INSTRUCTION MANUAL

GENERAL PURPOSE 3" OSCILLOSCOPE

MODEL 430 ADDENDUM

Figure 11. Model 430 Schematic Diagram

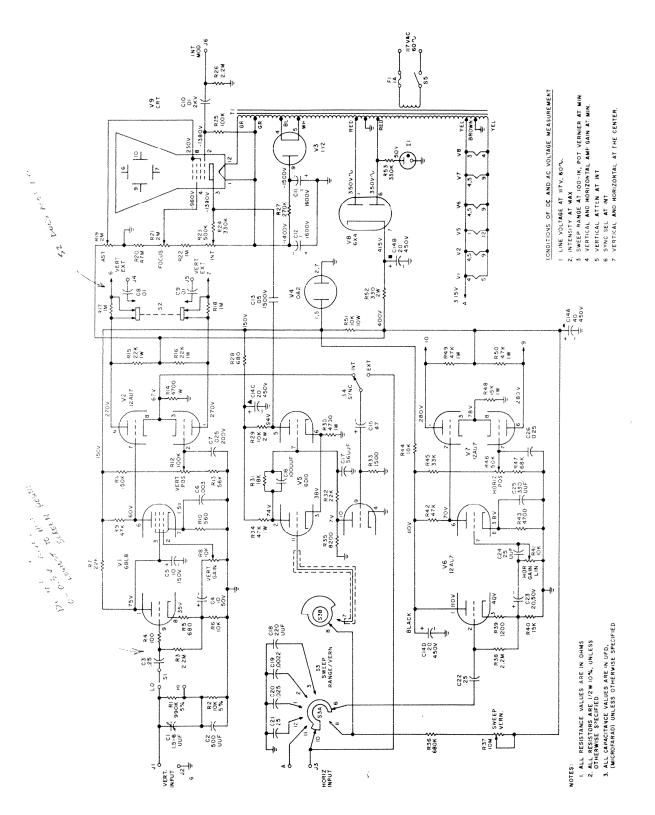
Page 22, Schematic Diagram: Change R15 and R16 from 1W to 2W

Change R33 from 1500Ω to $150K\Omega$ Change C26 from . 25ufd to . 025ufd

From V7 pin *1 at the end of the arrow change *10 to *9. From V7 pin *6 at the end of the arrow change *9 to *10. From R17 at the end of the arrow change pin *6 to pin *7. From R18 at the end of the arrow change pin *7 to pin *6.
